# Service Advisory

CC-671

MTD-115

**Subject:** **50" Deck Drive Belt Loss - Idler Bracket and Belt Guide**

**FIGURE 1**

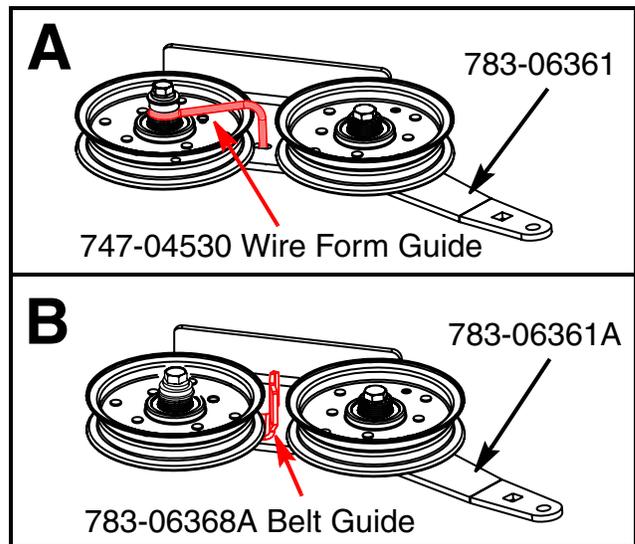
**SYMPTOM(S):** 50" deck drive belt jumps off the idler pulley and may result in belt, idler pulley and/or idler bracket damage. The new fabricated belt guide keeps the belt in closer into the idler pulley when deck drive is disengaged.

6. Look at the dual pulley idler. Does the existing belt guide look like the wire form guide in Figure 1A?

If NO, the existing belt guide looks like the fabricated one in Figure 1B, then the belt loss issue is due to something else other than the belt guide. Further inspection and analysis is required.

If YES, then order and install Service Kit **753-06413**  
See attached service kit instruction sheet.

**FIGURE 2**

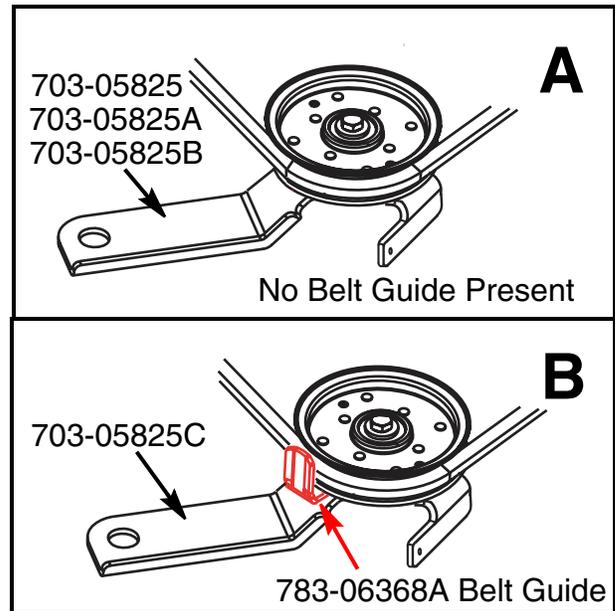
7. Refer to Figure 2A. Look at the single pulley idler. Is there an existing belt guide.

If YES, the existing belt guide looks like the fabricated one in Figure 2B, then the belt loss issue is due to something else other than the belt guide. Further inspection and analysis is required.

If NO, then order and install Service Kit **753-06414**.  
See attached service kit instruction sheet.

FIGURE 1

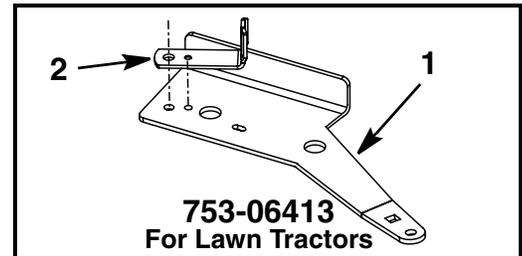
### Service Kit 753-06413 Contents for Lawn Tractors (See Figure 1)

14. Place the new Belt Guard, 783-06368A (Item 2), onto the new idler arm bracket. Ensure that the boss on the bottom of the belt guard sets into the hole provided in the idler arm bracket to properly orient the belt guard. See Figure 1.

FIGURE 2

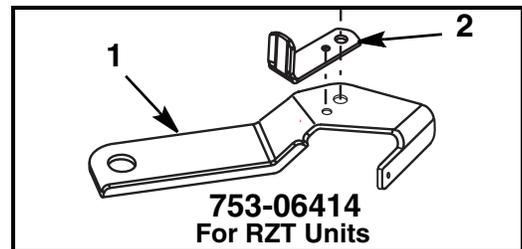
### Service Kit 753-06414 Contents For RZT Units (See Figure 2)

24. Place the new Belt Guard, 783-06368A (Item 2), onto the new idler arm bracket. Ensure that the boss on the bottom of the belt guard sets into the hole provided in the idler arm bracket to properly orient the belt guard. See Figure 2.

FIGURE 3

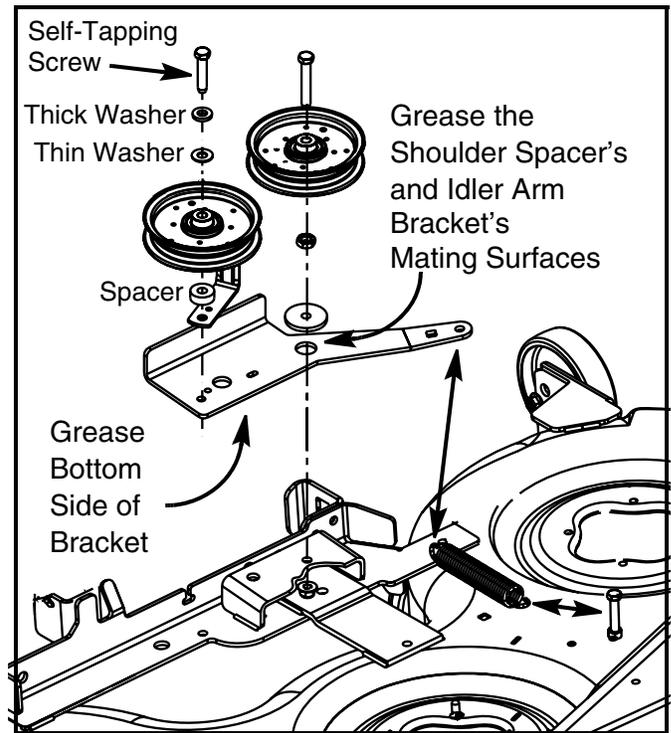
12. Grease the bottom side of the new Idler Arm Bracket, 783-06361A (Ref. Item 1), and the shoulder spacer's and idler bracket's mating surfaces.
  13. Install the new idler arm bracket and stationary idler pulley onto the deck using the hardware removed in Step 11. See Figure 3.

15. Refer to Figure 3. Using the parts removed in step 9, place the spacer, 750-3119, between the new belt guard and the pivoting idler pulley, 756-04129B.

17. Re-install the extension spring. See Figure 3.
  18. Re-install the deck drive belt. Replace if damaged.
  19. Re-install deck under the lawn tractor.

FIGURE 4

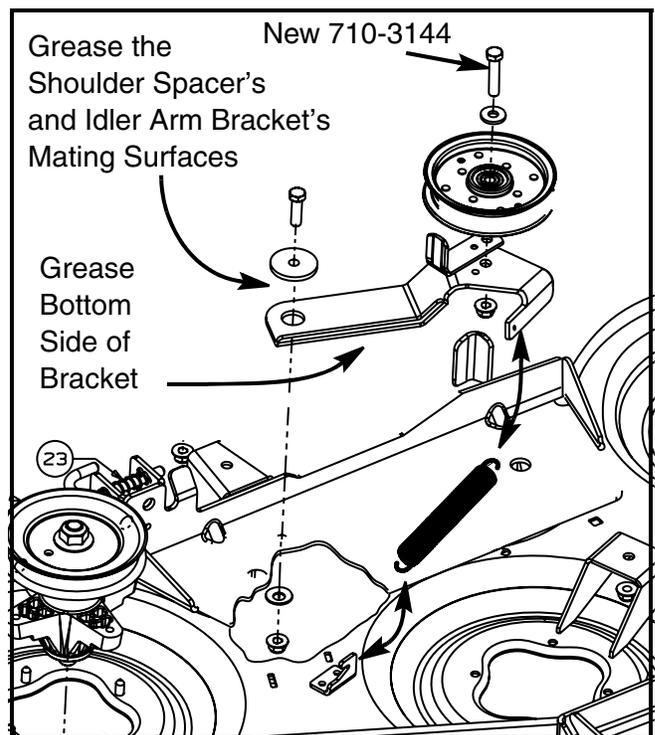
22. Grease the bottom side of the new Idler Arm Bracket, 703-05825C (Item 1), and the shoulder spacer's and idler arm bracket's mating surfaces.
23. Install the new idler arm bracket onto the deck using the hardware removed in Step 21. See Figure 4.

26. Re-install the extension spring. See Figure 4.
27. Re-install the deck drive belt. Replace if damaged.
28. Re-install deck under the RZT rider.
